PRODUCT CHANGE NOTIFICATION (PCN)

AMJE0909-0300-YEB-24
MODULAR CABLE

CHANGE NOTIFICATION: PCN 20220509_AMJE0909-0300-YEB-24

DESCRIPTION OF CHANGES:
CHANGE OF DATA SHEET
CHANGE OF DATA SHEET
New Draw.-No. ASS_7945_CArev02

AMJE0909-0300-YEB-24 OLD VERSION

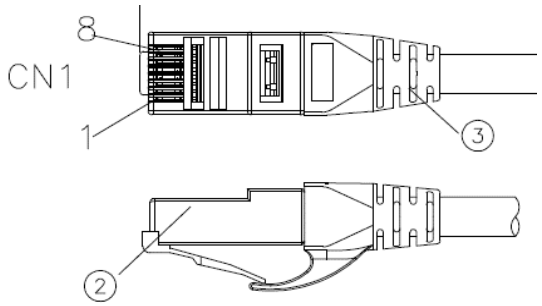
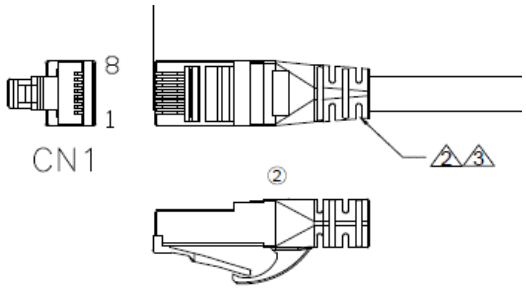
③	Molding	PVC 45P Color: see order code	NA	KG
②	CONNECTOR	RJ45 8P8C two fork Short type 3u" gold plated	2	PCS
①	CABLE	CAT6 UTP (24AWG*1PR)*4+PVC OD=5.8±0.3MM Color: see order code	NA	MM
NO:	NAME	DESCRIPTION	Q'TY	UNIT

3	Molding	PVC 65P Color: see order code ②	NA	KG
2	CONNECTOR	RJ45 8P8C PLUG 3u" gold plated ②	2	PCS
1	CABLE	CAT6 U/UTP (24AWG*1PR)*4+Cross+PVC Jacket OD=5.8± 0.3MM Color: see order code ②	NA	MM
NO:	NAME	DESCRIPTION	Q'TY	UNIT

Drawing-No.
ASS 7945 CA

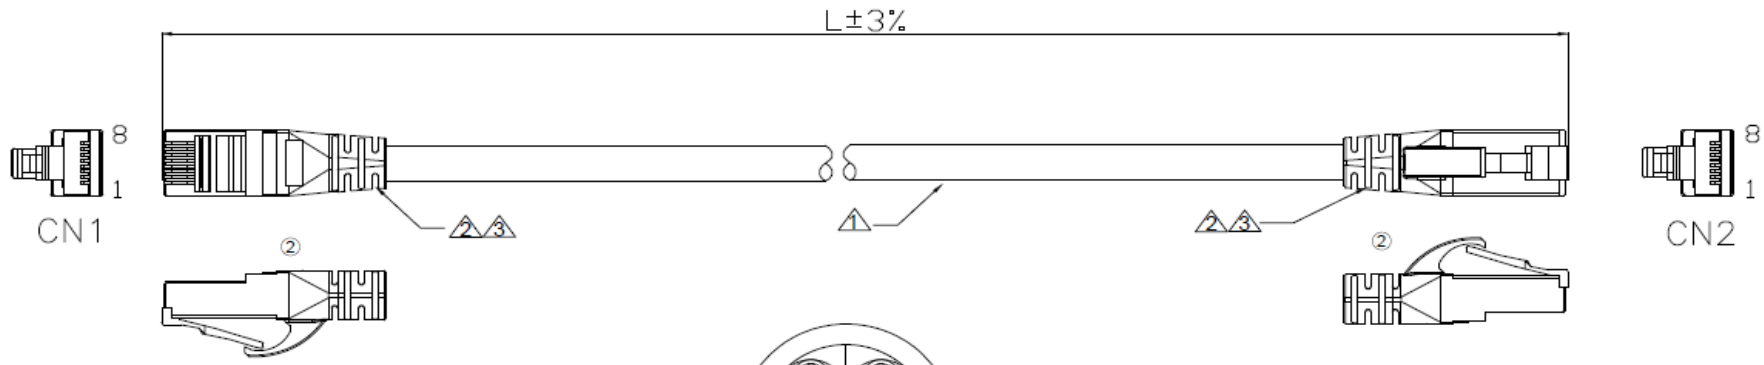
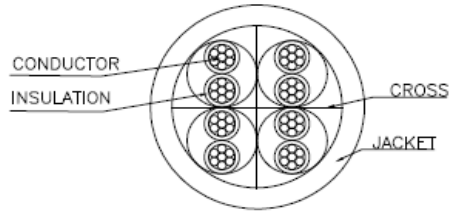
Id.	Modification	Date	Name
②	Change the plant	09.05.2022	Luca
①	Update the WSW order code	02.06.2017	Amy
⓪	Drawn	30.03.2017	Amy

NO:	NAME	DESCRIPTION	Q'TY	UNIT
3	Molding	PVC 65P Color: see order code ②	NA	KG
2	CONNECTOR	RJ45 8P8C PLUG 3u" gold plated ②	2	PCS
1	CABLE	CAT6 U/UTP (24AWG*1PR)*4+Cross+PVC Jacket OD=5.8± 0.3MM Color: see order code ②	NA	MM
